Subject: REVISION: N242451390-01 – Service Update  
First Responder Emergency Cut Loop Label Removal  
Population Expansion

## N242451390 First Responder Emergency Cut Loop Label Removal

**Revision:** 01

6692423

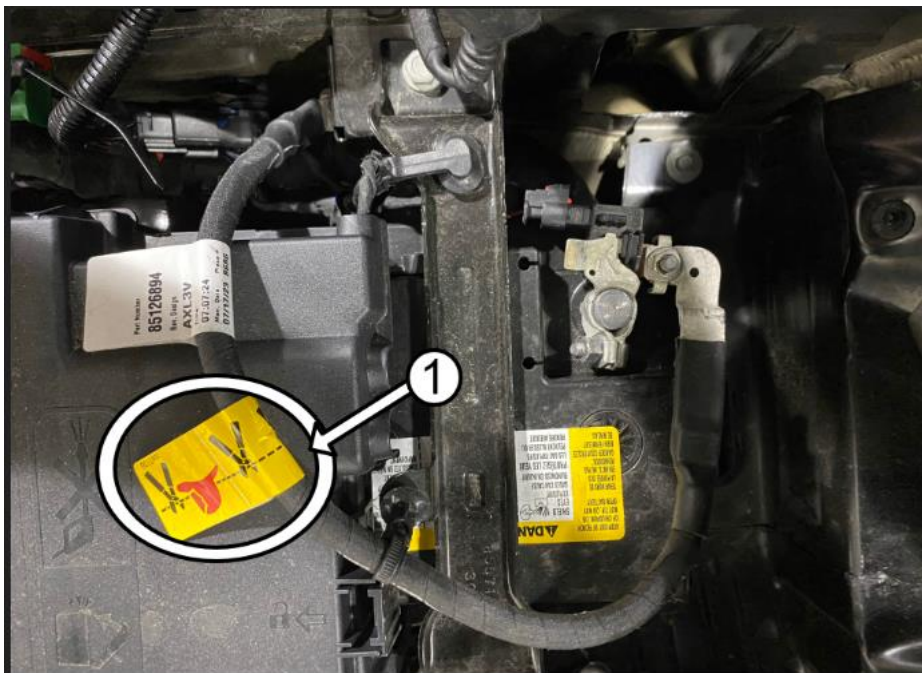
**Note:** GMC HUMMER EV shown.

**Important:** DO NOT remove the High Voltage Service Lockout Emergency Cut Loop Label.

**Caution:** Use caution to avoid damaging the 12V Battery Negative cable conduit.

2. Using a sharp cutting tool, remove the First Responder Emergency Cut Loop label (1) from the 12V Battery Negative Cable.
3. Install the Right Front Compartment Rear Sight Shield. Refer to *Front Compartment Rear Sight Shield Replacement - Right Side* in SI.

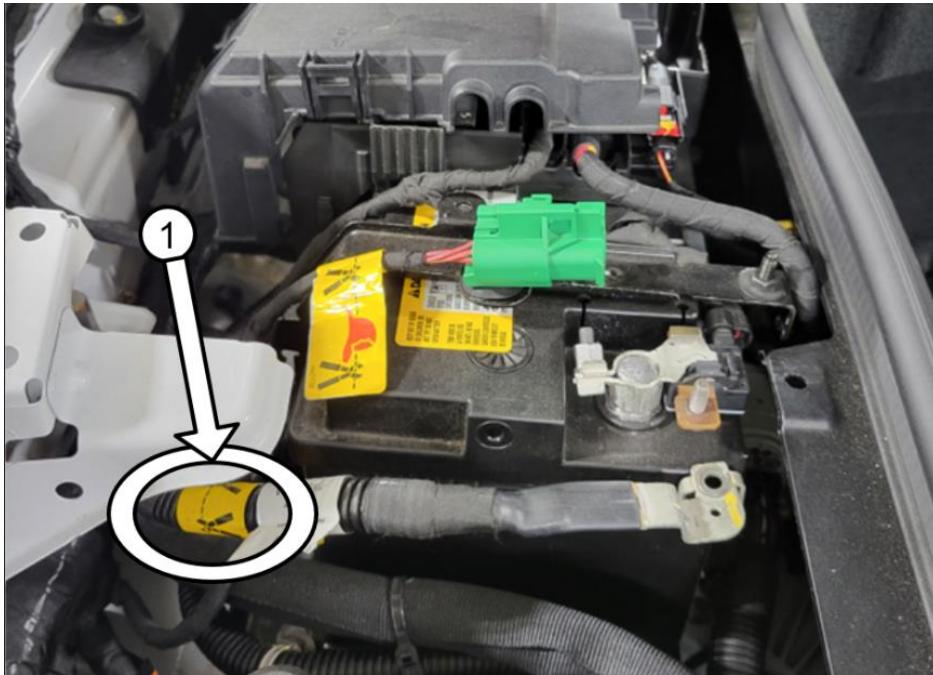
**Note:** Cadillac Escalade IQ shown.
